RTL8102EL/8103EL/8111DL Circuit

Rev. 1.08

Realtek Semiconductor Corp.		
Title RTL8102EL/8103EL/8111DL circuit: Index		
Size A4	Document Number RTL8102EL_8103EL_8111DL_108.DSN	Rev 1.08
Date: Thursday, June 11, 2009 Sheet 1 of 8

Realtek Semiconductor Corp.			
Title			
RTL8102EL/8103EL/8111DL circuit: POWER			
Size	Document Number	Rev	
A3	RTL8102EL_8103EL_8111DL_108.DSN	1.08	
Date:	Thursday, June 11, 2009	Sheet	2 of 8

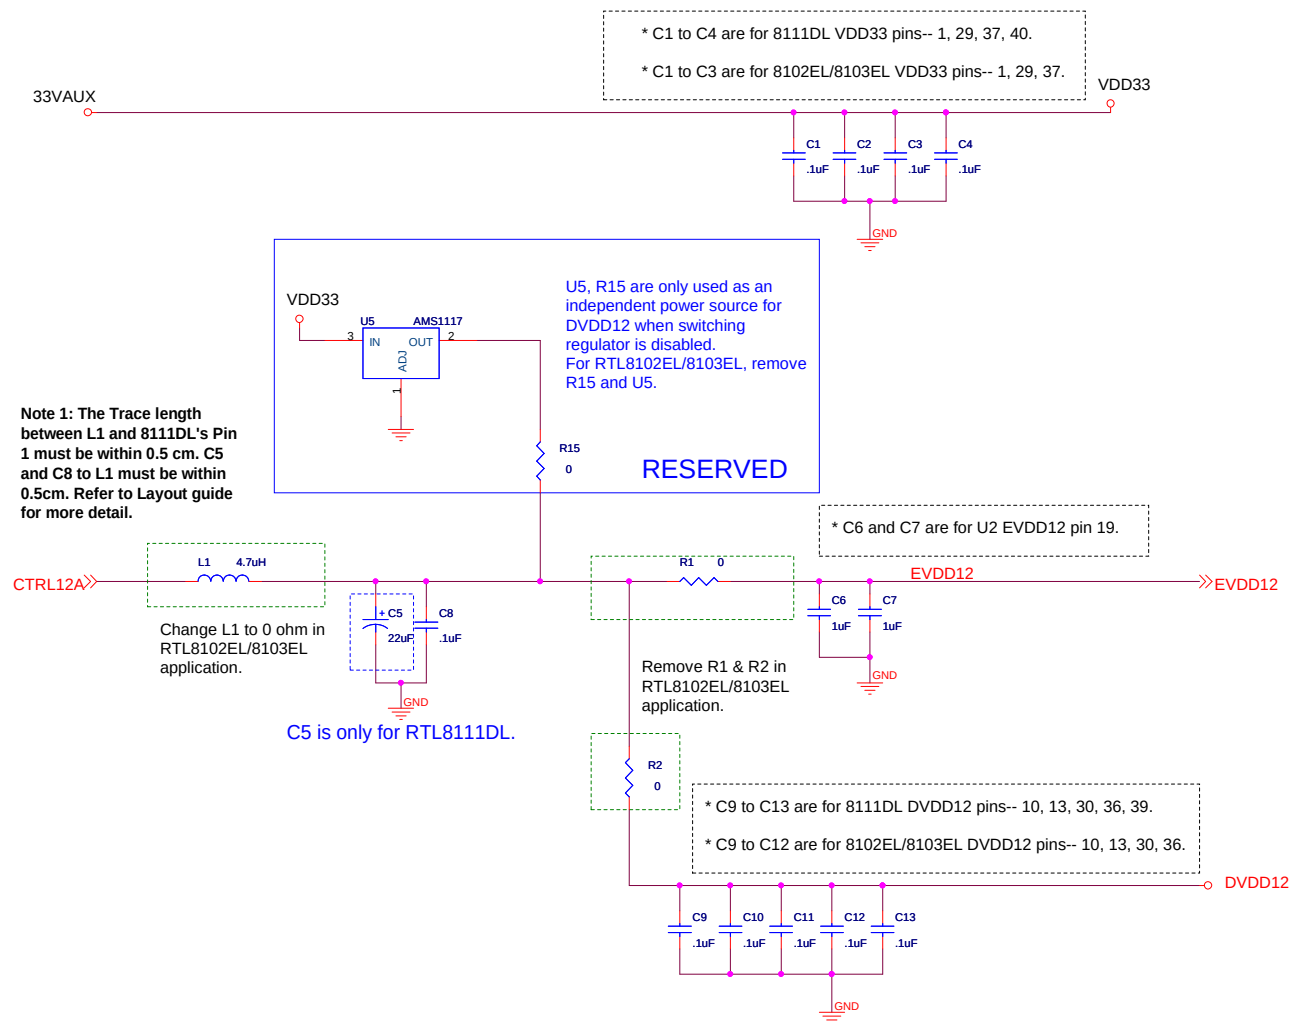
1. Add reserved circuit for independent 1.2V source. (Page 2)
2. Update comment about R5 and R6. (Page 3)
3. Update RTL8111DL BOM list. (Page 3)
4. Add RTL8103EL circuit and BOM List.

1. Update RTL8102EL, 8103EL, 8111DL BOM List.
2. Add comment about C6 for 8111DL application. (Page 2)
3. Add comment about R13. (Page 3)

1. Update 8102EL, 8103EL BOM List.
2. Modify C4 comment for the 8102EL/8103EL application. (Page 2)
3. Modify R5 and R6 comment for the 8111DL application. (Page 3)
4. Add optional ESD protection array circuit for the 8111DL application. (Page 3)
5. Add DSM reference circuit page. (Page 4)

1. Change C7 from 0.1uF to 1uF for RTL8102EL, RTL8103EL and RTL8111DL. (Page 2)
2. Update 8102EL, 8103EL and RTL8111DL BOM List.
3. Modify comment about R13 for RTL8103EL. (Page 3)

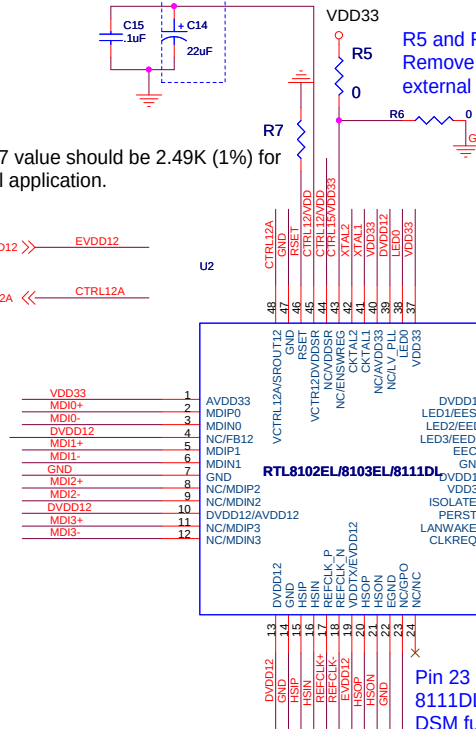
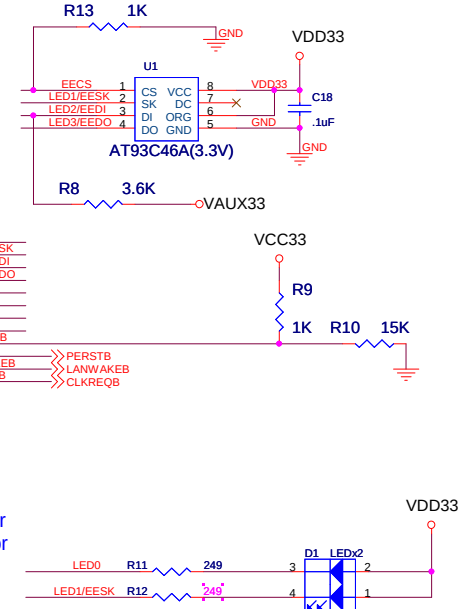
1. Change R13 from 10K to 1K (Page 3)
2. Update ESD Protection array reference part to SRV05-4, TCT. (Page 3).

Remove R5 and R6 for RTL8102EL/8103EL application.

R5 and R6 are used in the RTL8111DL application. Remove R6 if switching regulator is enabled. Remove R5 if external power 1.2V is used.

R13 is only required by RTL8102EL and RTL8103EL.
